LAND USE BOARD APPLICATION

FOR OFFICIAL USE	ck xxx 9857	MP	
Date Rec'd: <u>8/21/2024</u>	Application #: <u>LB24-05</u>	Fee: <u>\$350</u>	Escrow: <u>\$750</u>

McGHEE RESIDENCE

43 Gravelly Point Road
Highlands, NJ

3 PROPOSED LAYOUT PLAN
SCALE: 1/8" = 1'-0"

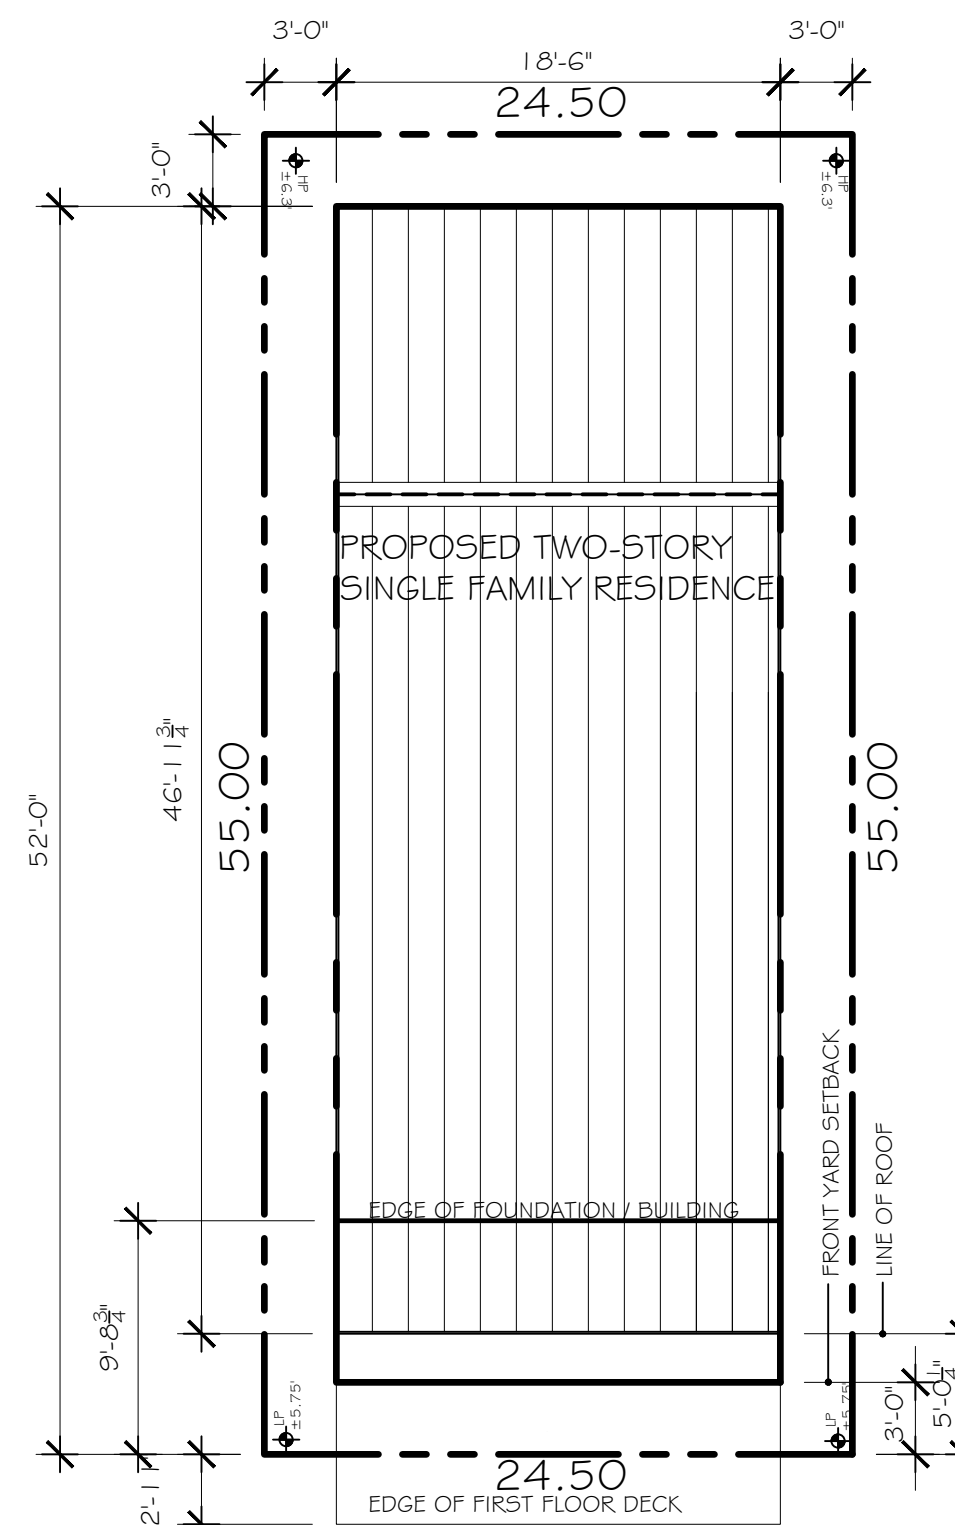
- Please confirm the front yard setback of 9.02 ft. The front yard setback distance is noted on the zoning table shown on Sheet 3 of the Architectural plan set, however the same is not shown on the accompanying plot plan. Please indicate the front yard setback distance on the plot plan.

Please provide a proper plot plan indicating the proposed dwelling on the survey, existing dwellings on the adjoining lots, existing and proposed grades and the road name. Please indicate the lawn and pavement areas to the north of the lot and the road name.

9. Runoff appears to flow towards the sides and pond at the back of the lot. Applicant to propose grading to direct water away from the side and back lots, and towards the roadway. Runoff shall not flow onto adjoining properties. Provide existing and proposed elevations at all building and property corners including midpoints of same.
10. Please indicate roof leaders and how the discharge is managed to not impact adjoining properties.
11. Please provide the location of the existing and proposed utilities.

4. **VI.1:** A plot plan showing the proposed structure is provided on the design drawings. Additional information requested has been provided. The lawn and pavement areas to the north of Lot 26.43 are an impervious surface parking area for the apartment buildings to the north. We are not providing additional survey information in this submission as the Lot in question is at a lower elevation than the parcel to the north.

9. **VI.7:** Refer to drawing PM-102.00 for proposed parking spaces, 1 covered in the garage, 1 un-covered on existing compacted soil.
10. **VI.8:** Refer to drawing PM-102.00 for surface material locations.

11. **VI.9:** Water runoff flows from the rear of the property to the front of the property. Refer to the plot plan on PM-102.00.
12. **VI.10:** Gutters and rain leaders are not provided. Rain dispersion system is proposed and noted on drawing A-203.00.

DRAWING NAME
PROPOSED ROOF PLAN & DETAILS

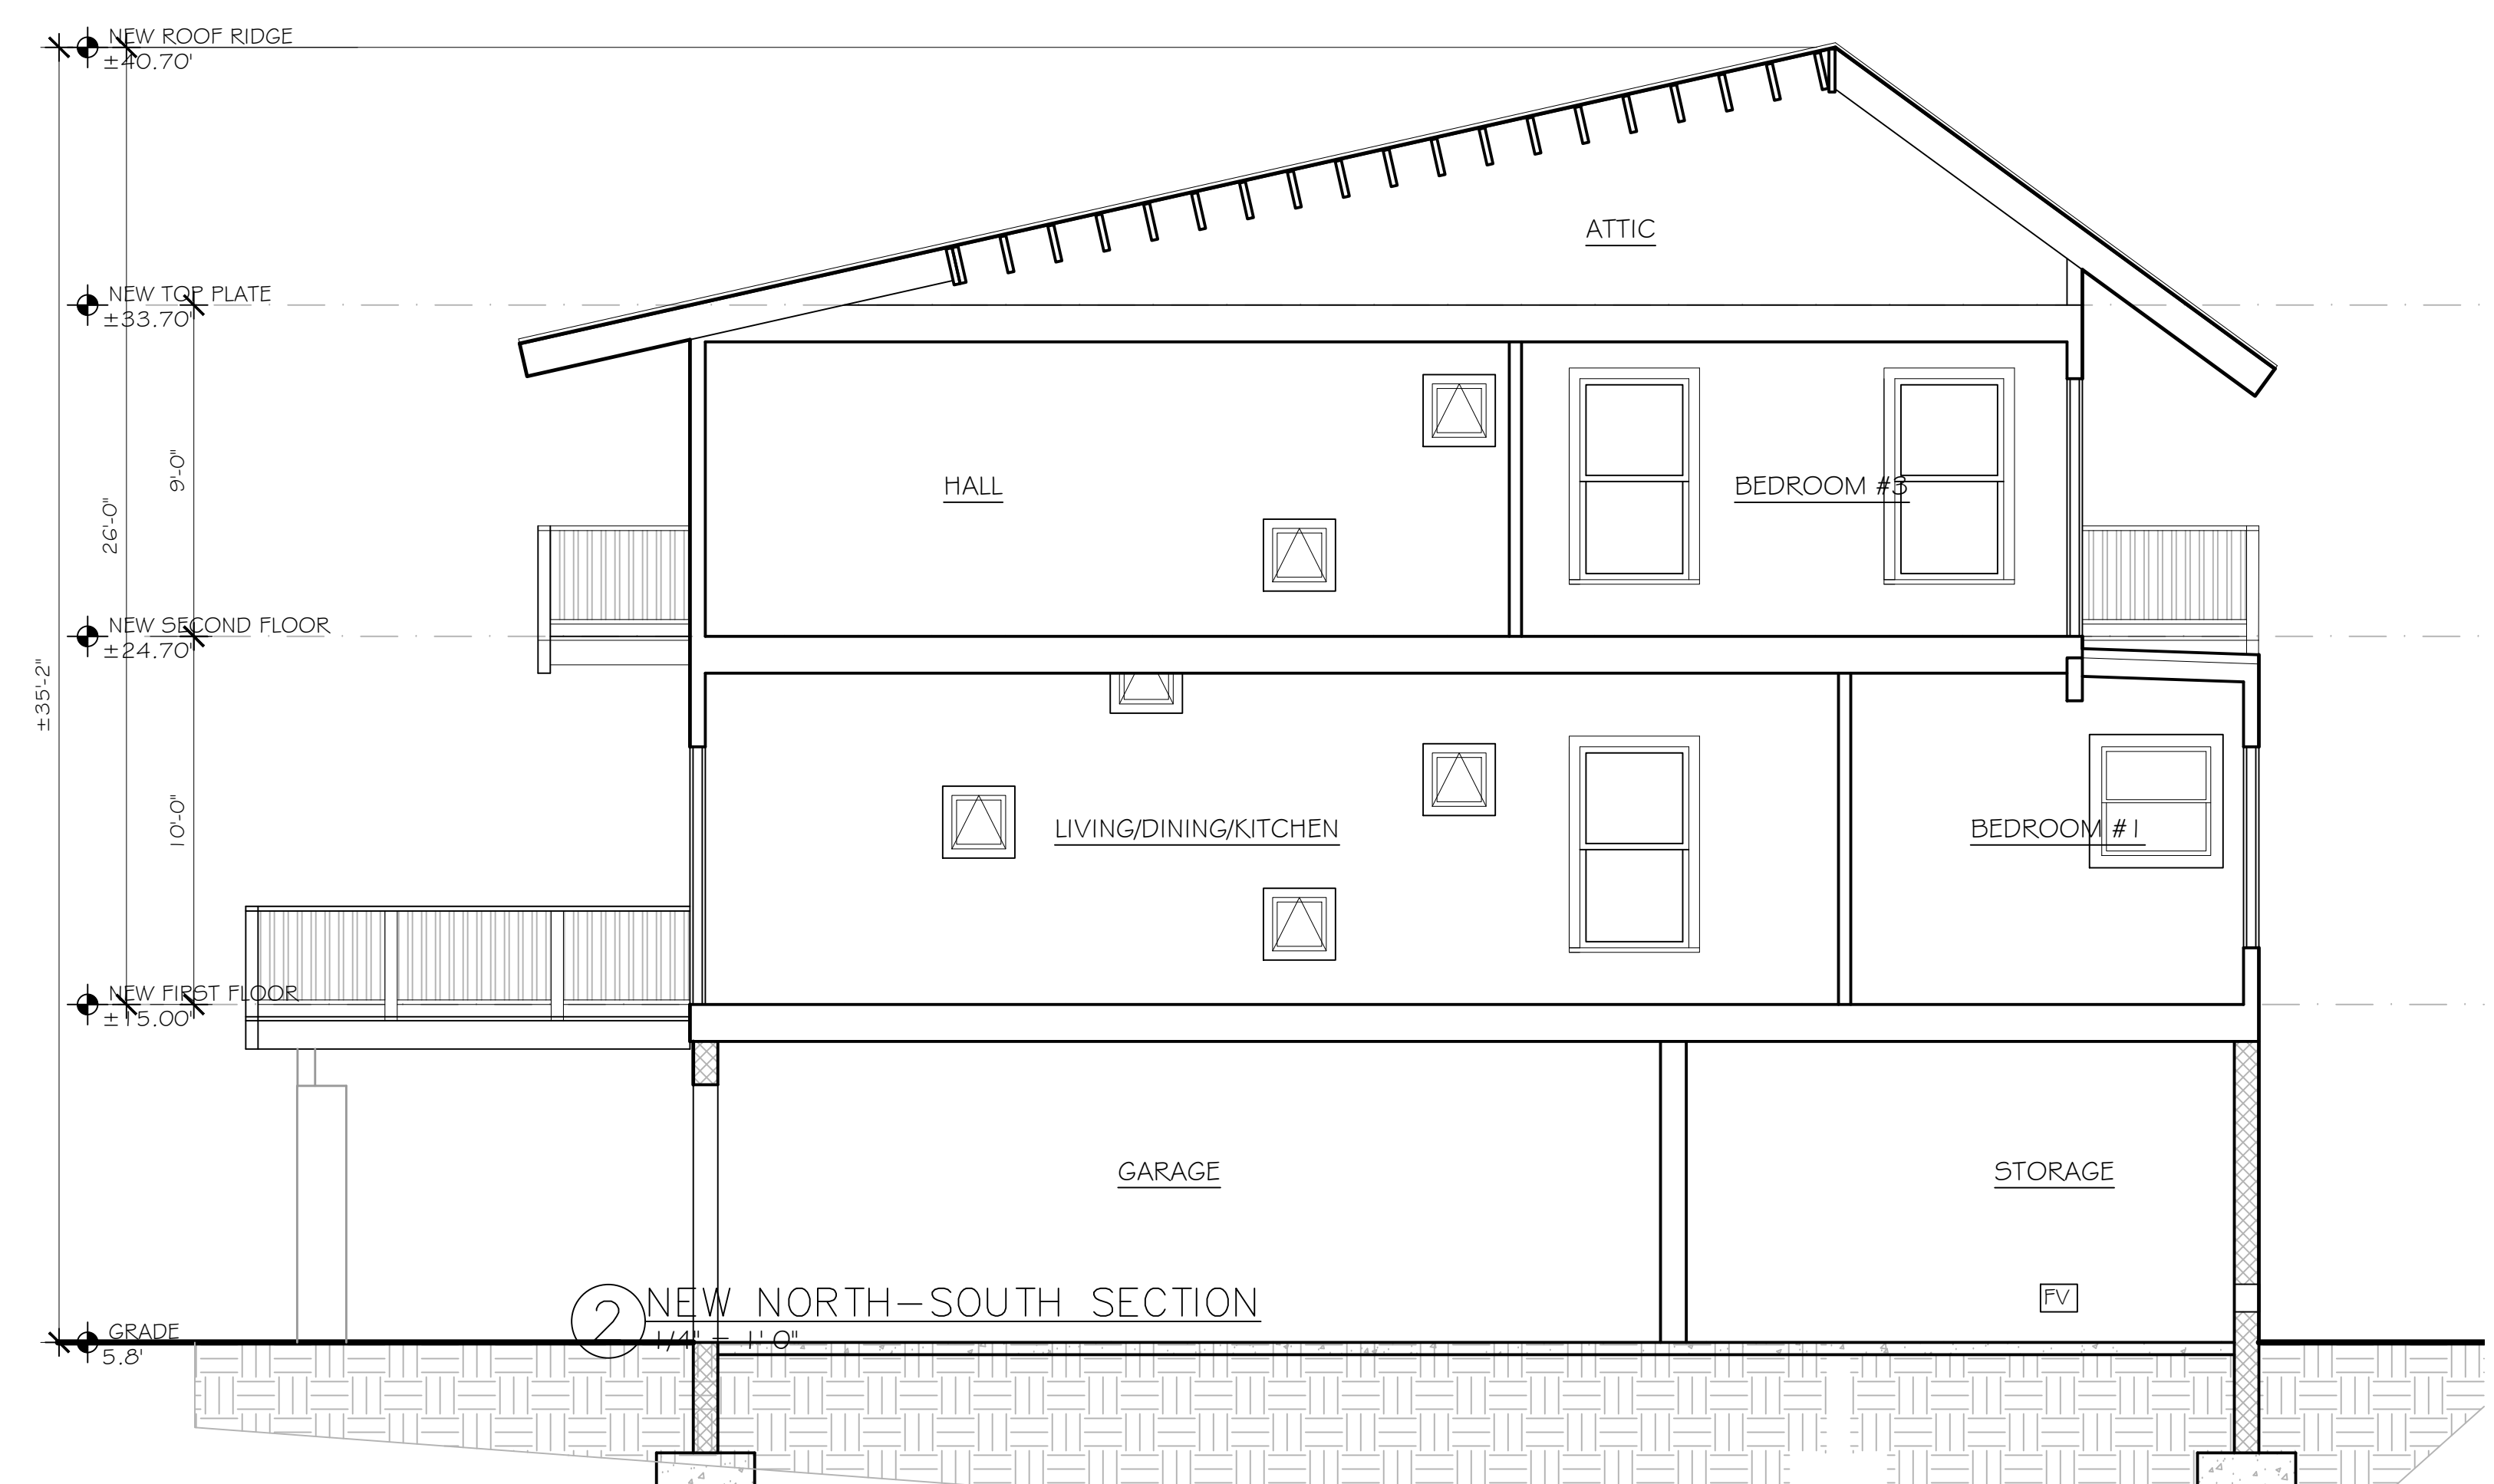
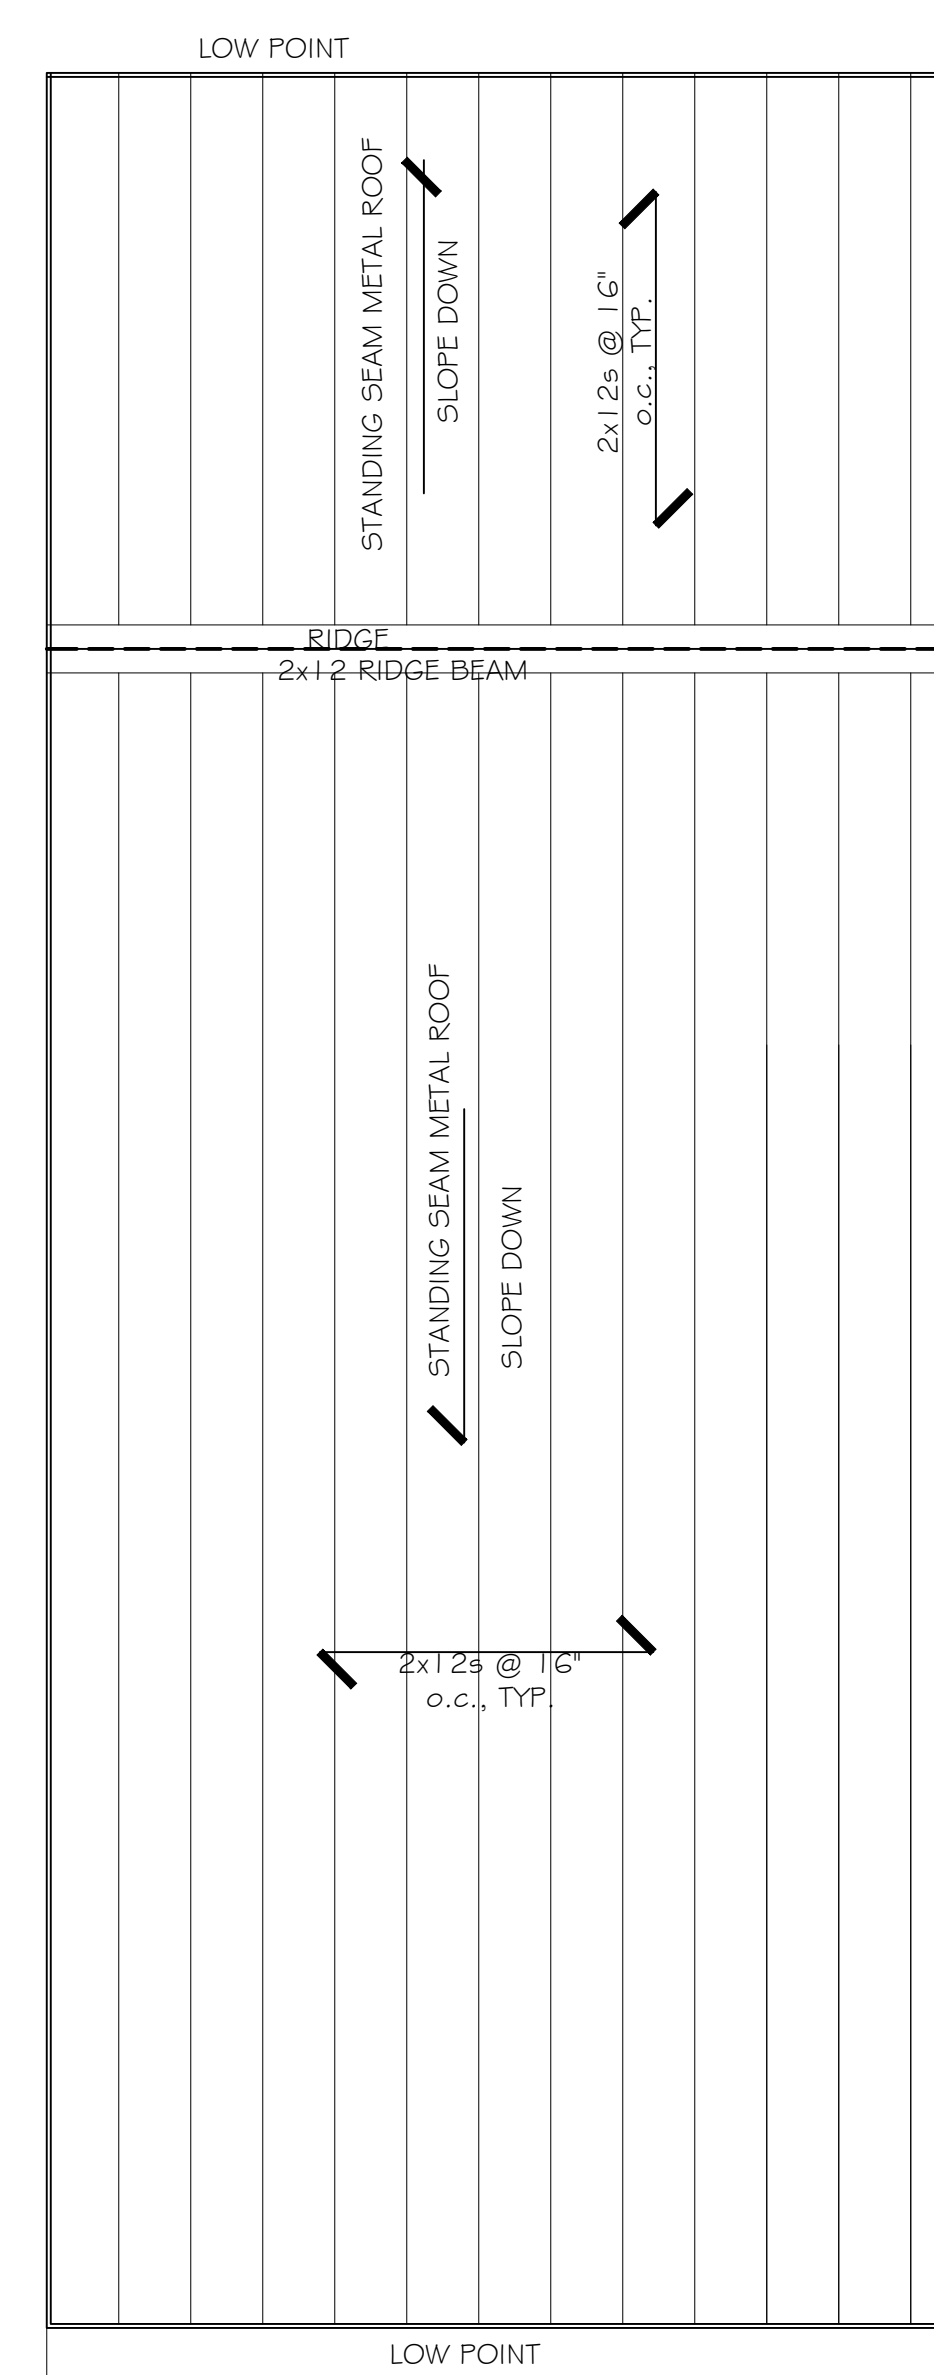
5. In accordance with §21-86A.4.b(2)(c) for bungalow colonies, the noted total building coverage and total lot coverage does not apply thus no variance for the building coverage is required for Lot 26.43.
6. Applicant to demonstrate that runoff shall not flow onto adjoining properties. Provide existing and proposed elevations at all building and property corners including midpoints of same and the roadway.
7. Please explain how the rain dispersion system manages roof runoff and how the discharge is managed to not impact adjoining properties.
